# UNITED STATES PATENT AND TRADEMARK OFFICE

APPLICATION NO.	FILING DATE	FIRST NAMED INVENTOR	ATTORNEY DOCKET NO.	CONFIRMATION NO.
10/021,922	12/13/2001	Marko Eromaki	442-010738-US(PAR)	2222
2512	7590	08/16/2005	EXAMINER	
PERMAN & GREEN 425 POST ROAD FAIRFIELD, CT 06824			CHIANG, JACK	
			ART UNIT	PAPER NUMBER
			2642

## Office Action Summary

Fig. 7

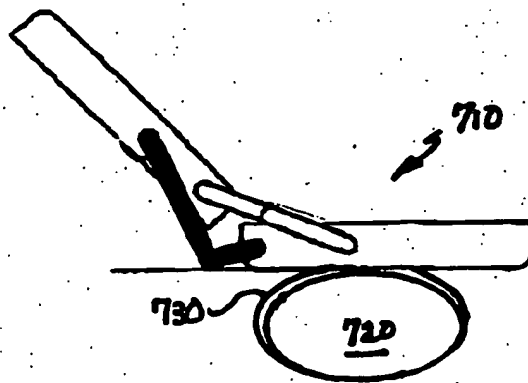
1. The drawings are objected to under 37 CFR 1.83(a). The drawings must show every feature of the invention specified in the claims. Therefore, the "... a wrist wearable form" called for in claim 17 must be shown or the feature(s) canceled from the claim(s). No new matter should be entered. (See also the argument section).

The examiner will duplicate applicant's original page 8, lines 6-7 as follow: "individual numbers from the display 12.". It is not seen that there is any support for the wrist wearable form of the device, not to mention the specific newly added feature in the newly added fig. 7. Therefore, proposed specification and drawing filed on 6/6/06 will not be entered.

Not  
Approved
